EA Project No.: 16-1100

DATE OF ISSUANCE: February 14, 2017

Notice: This addendum is issued to all prospective bidders as an amendment to the Drawings and Project Manual for the Canopy Row. Bidders shall acknowledge this addendum on the Bid Form. All information contained herein shall be fully incorporated into the Contract Documents as though originally included therein.

2 ENLARGED CEILING PLAN- SUITE K
A770 SCALE: 1/4" = 1'-0"

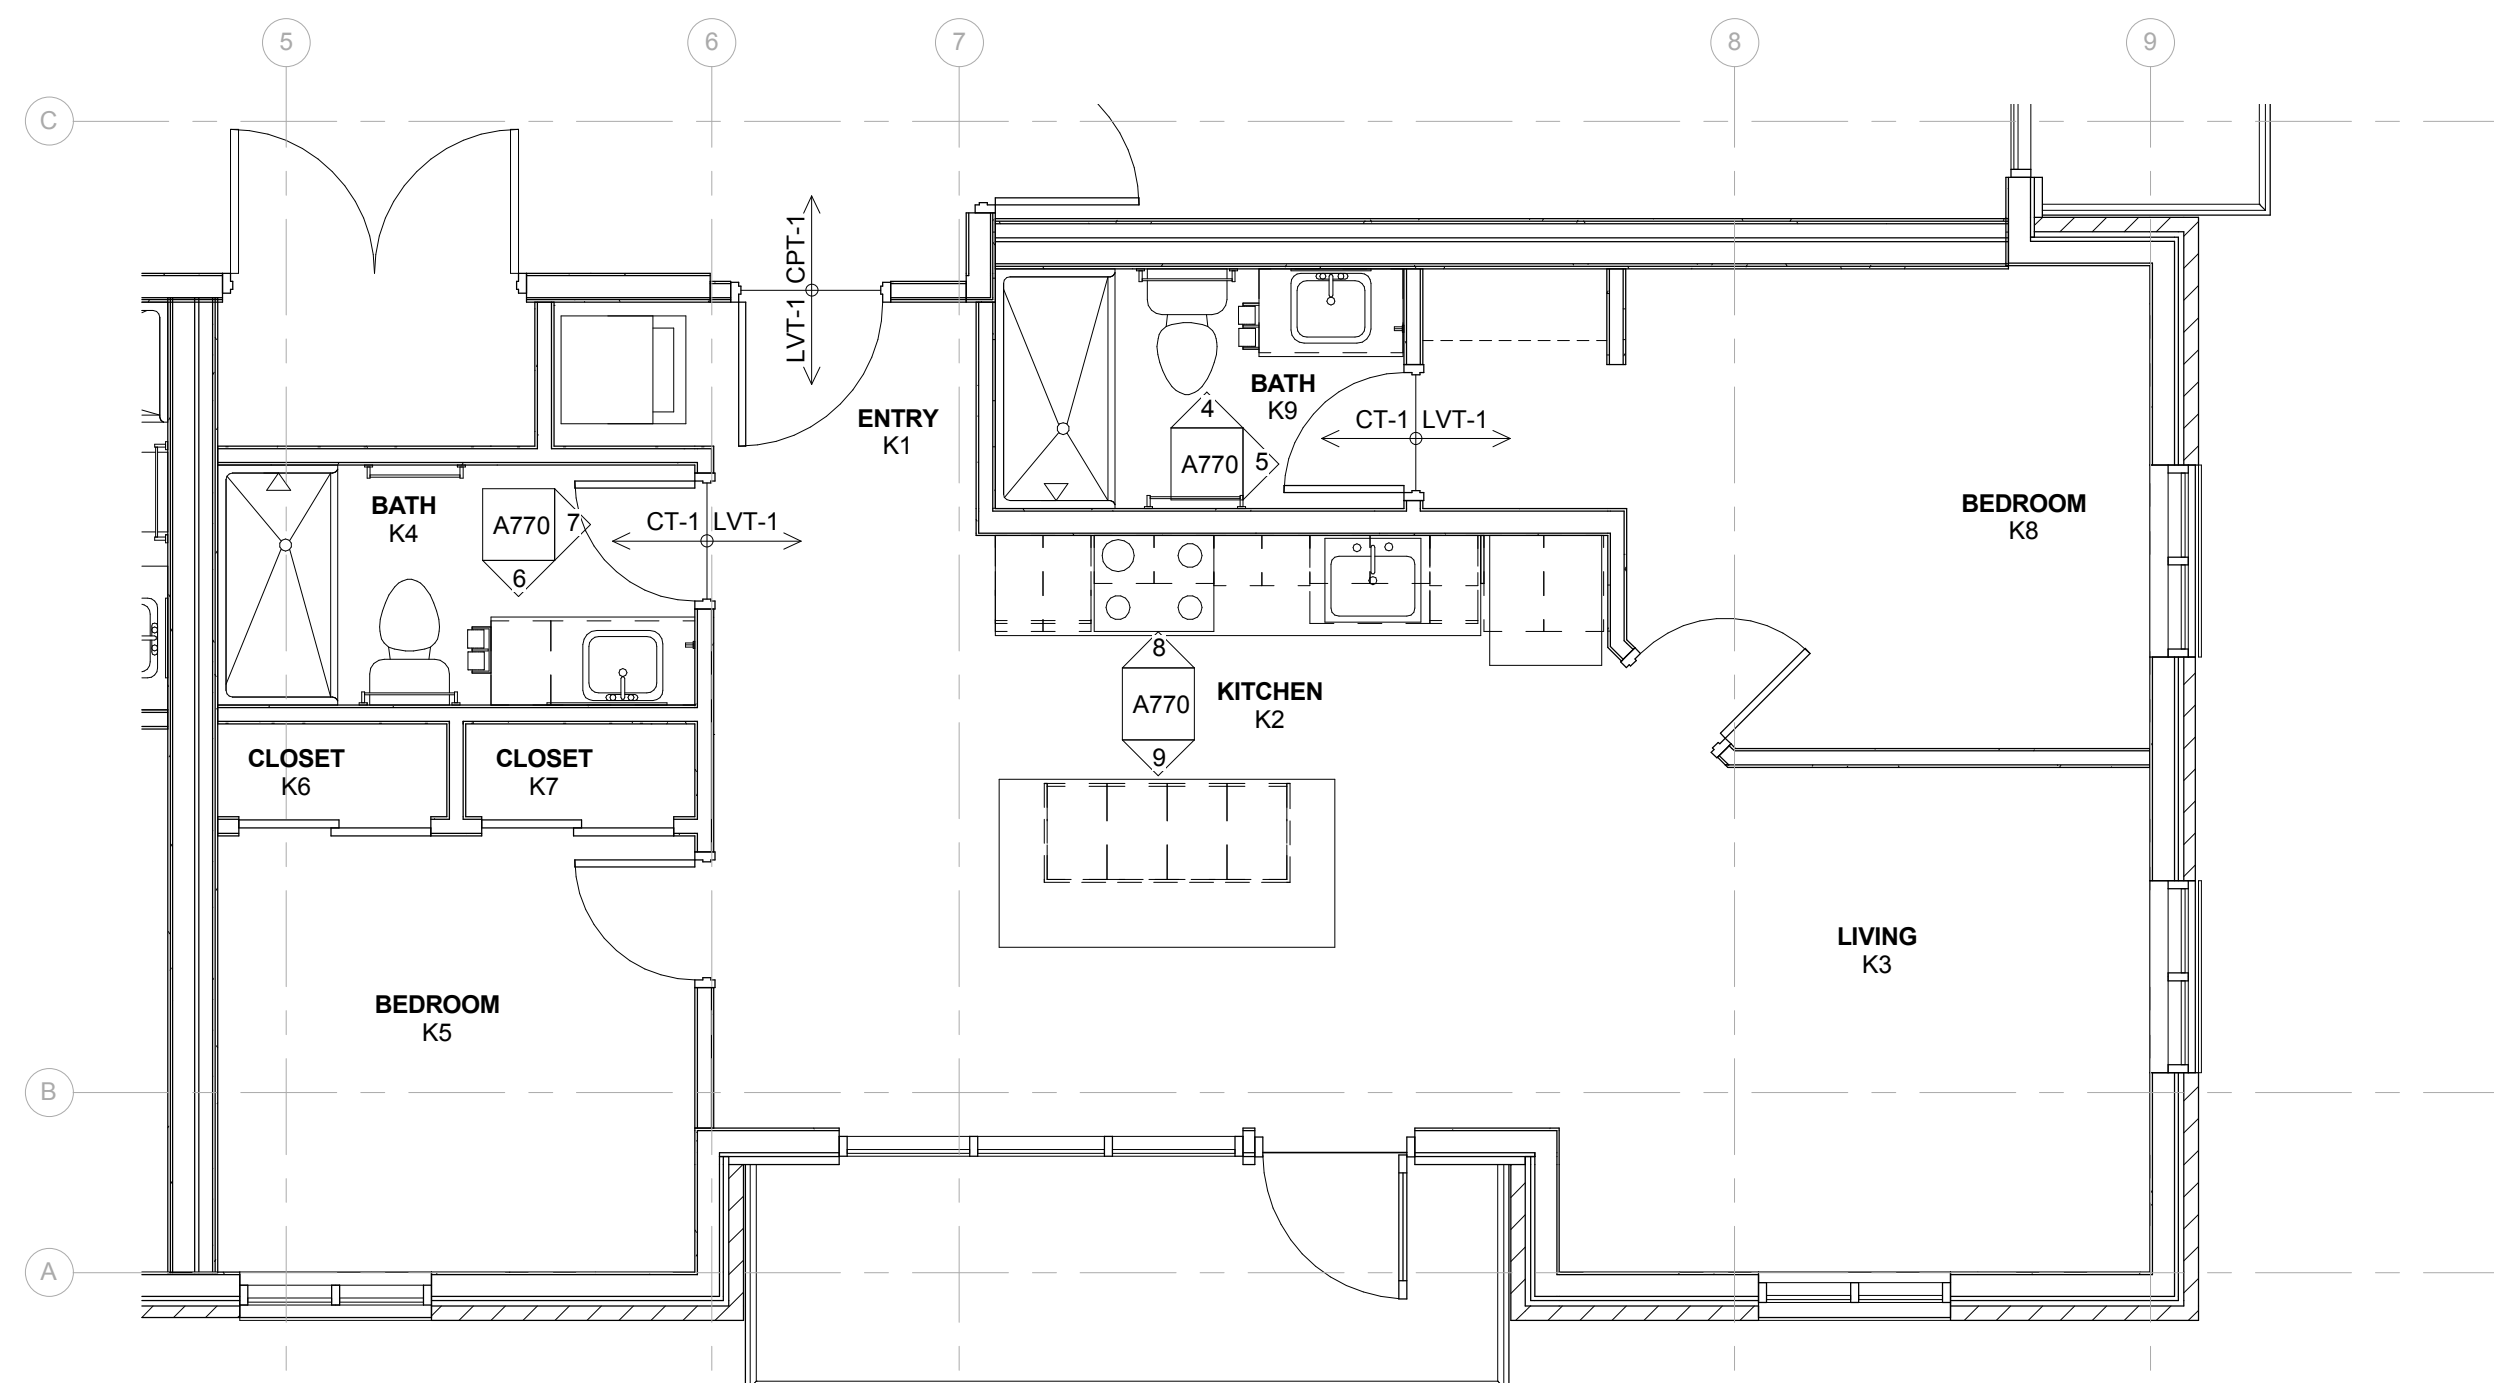
- Item AD-22. Sheet A769 – Suite J
 - a. Revise details 2/A769 as indicated on attached sheet A769.
- Item AD-23. Sheet A770 – Suite K
 - a. Revise details 2/A770 as indicated on attached sheet A770.

3 ENLARGED CEILING PLAN - COMMON A200
A772 SCALE: 1/4" = 1'-0"

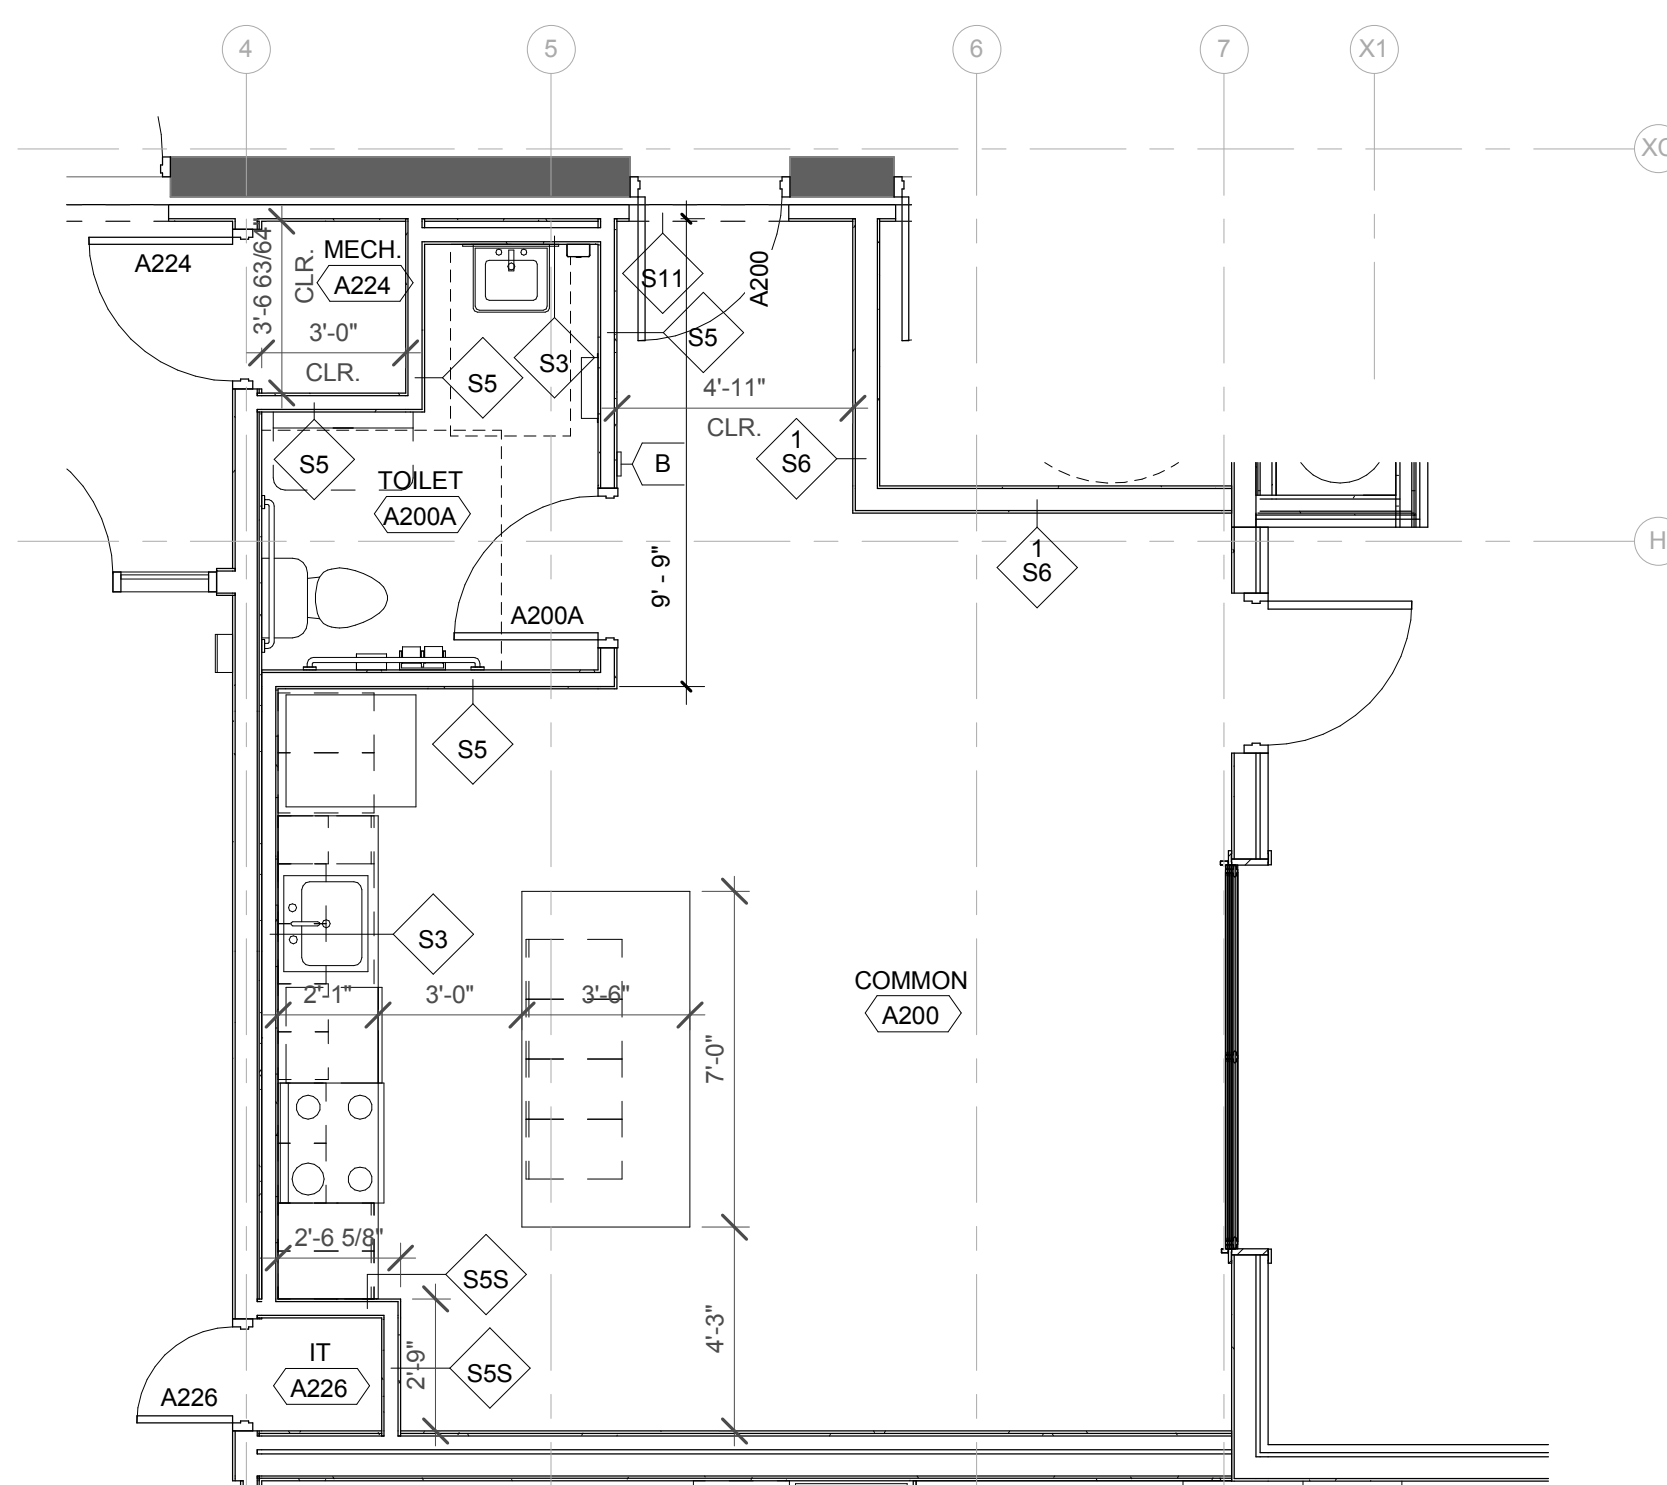
- Item AD-24. Sheet A771– Suite L
 - a. Revise details 4/A771 as indicated on attached sheet A771.
- Item AD-25. Sheet A772 – Common A200/ Office C200
 - a. Revise details 3/A772 as indicated on attached sheet A772.

S504

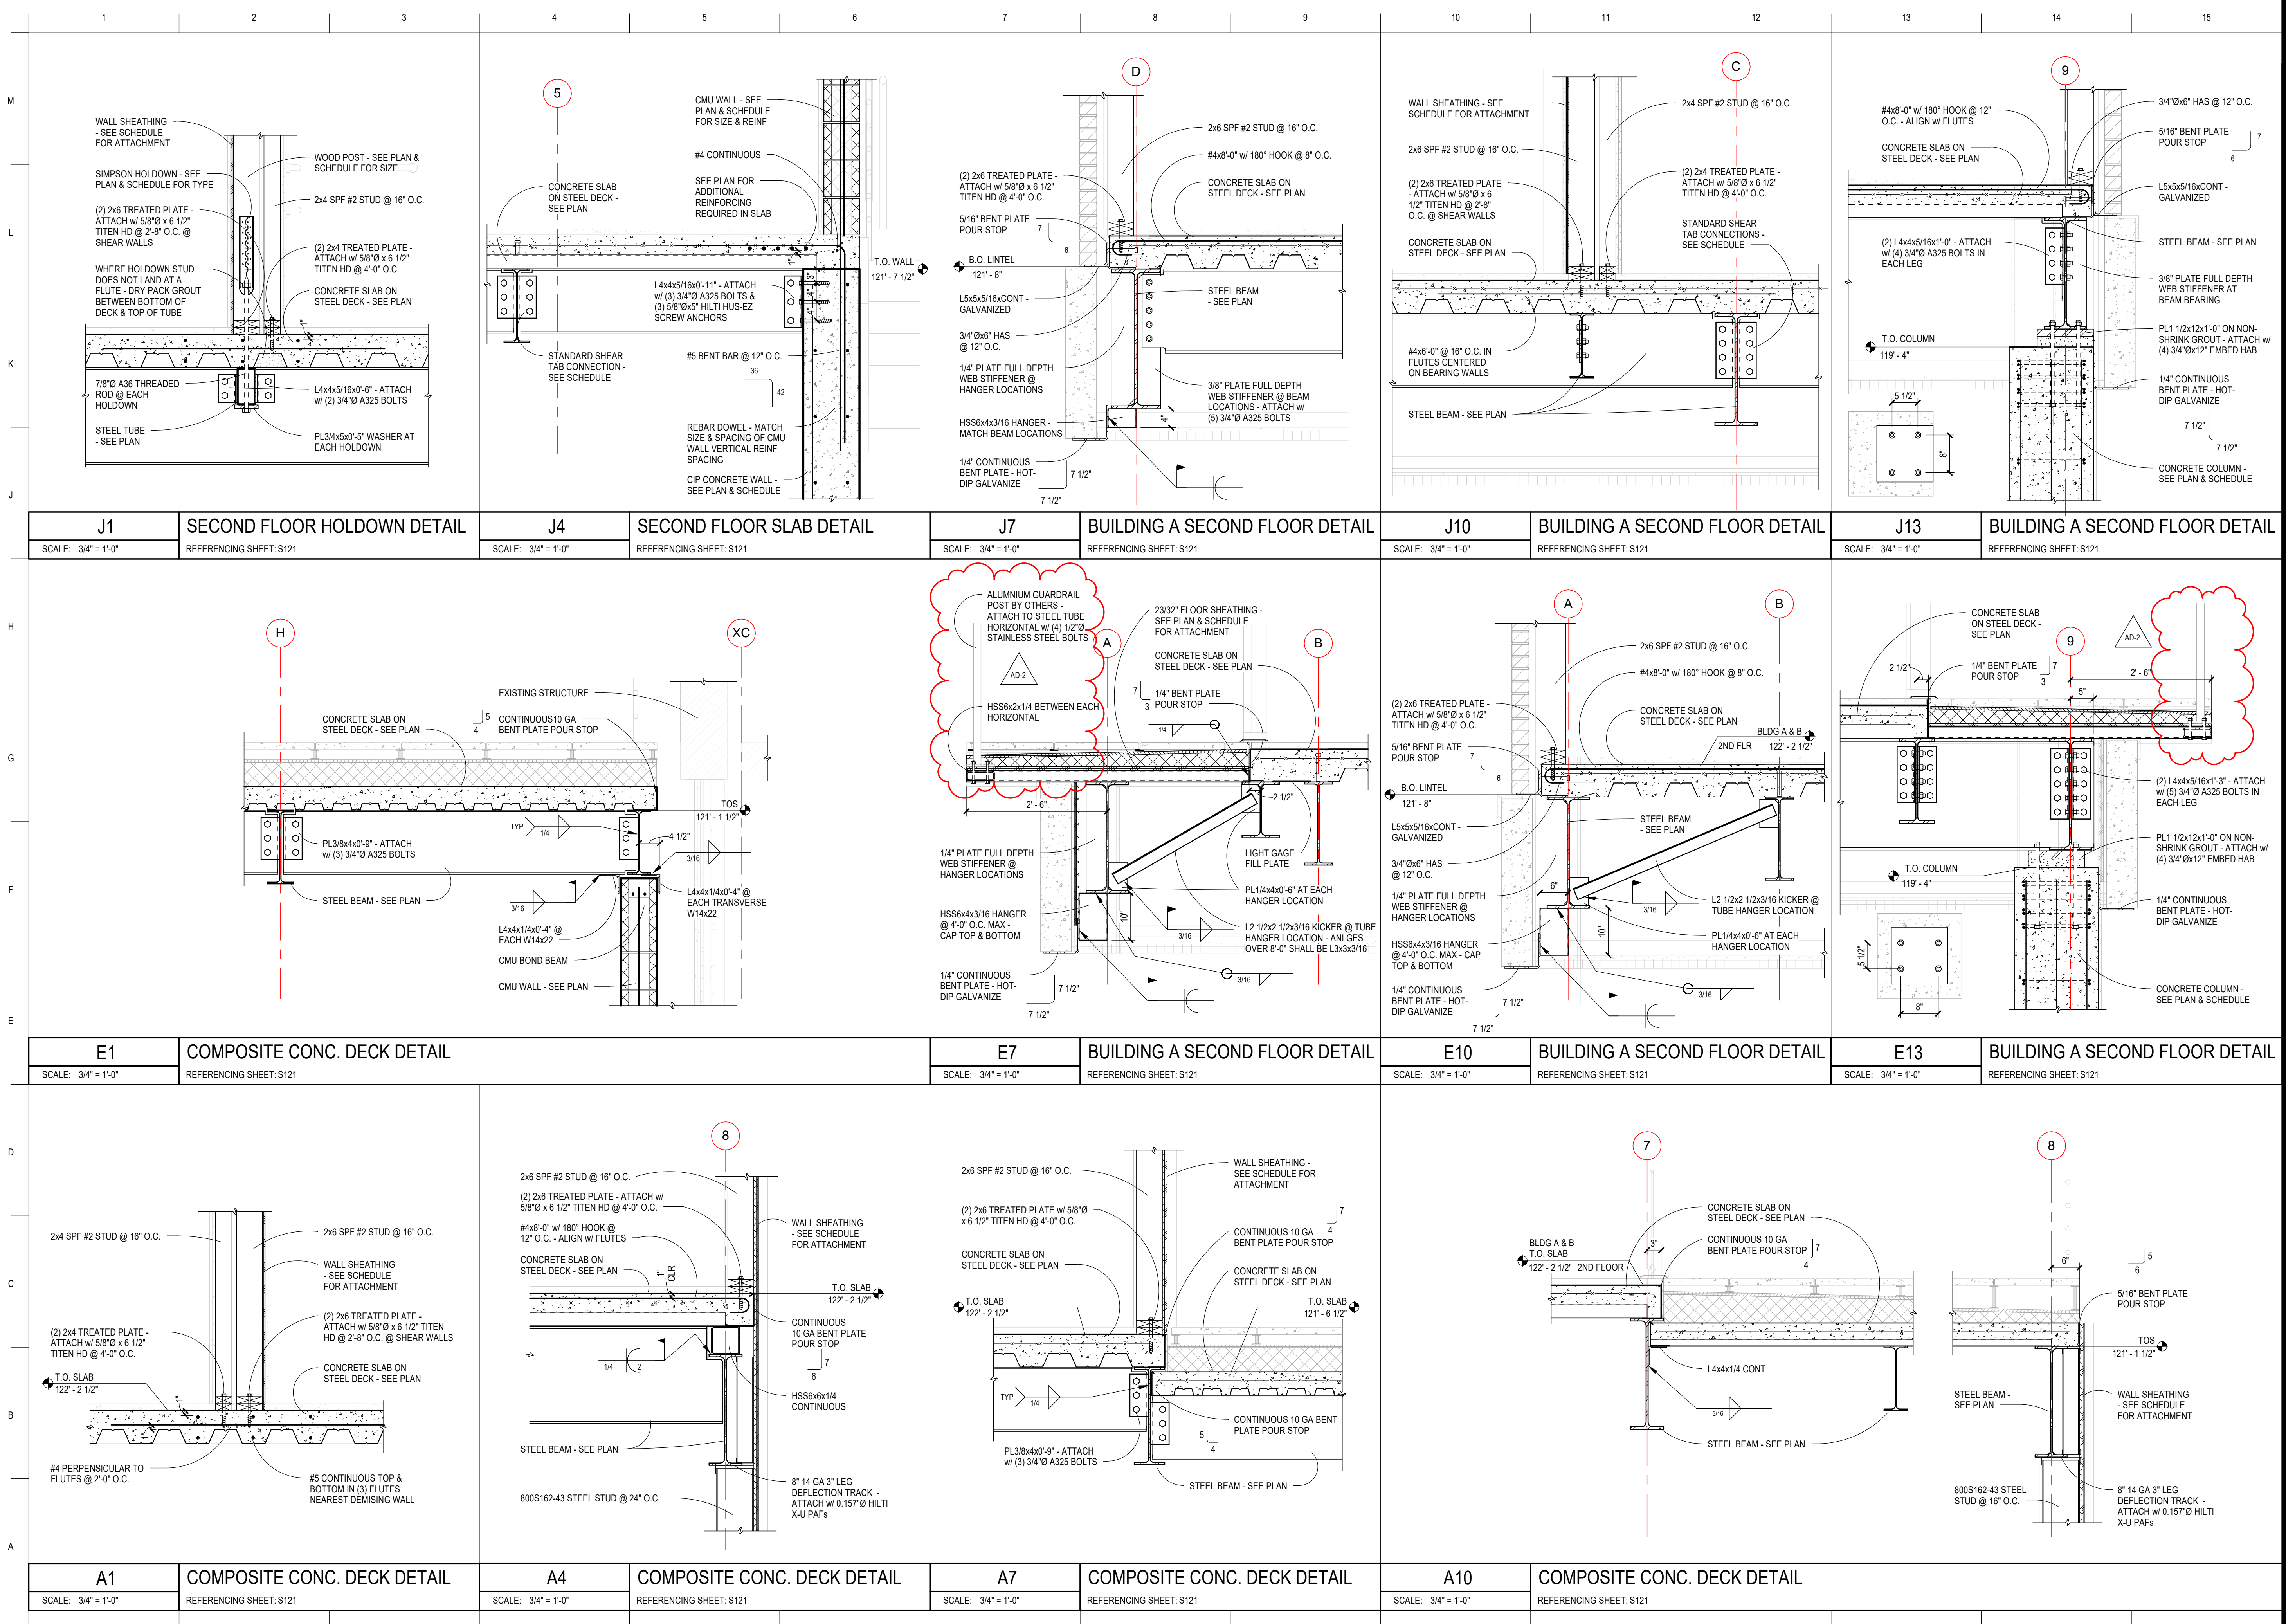
- Item AD-26. Sheet S005 – Structural Schedules
 - a. Revise Sheathing Attachment Schedule as indicated on attached sheet S005.
- Item AD-27. Sheet S504 – Structural Details

- a. Revised guardrail attachment to steel framing
 - b. Detail J1/S504 – Engineer will work with general contractor on constructability issues. The anchor can be installed before floor is poured and shear wall holdown stud can be shipped loose and nailed in place.
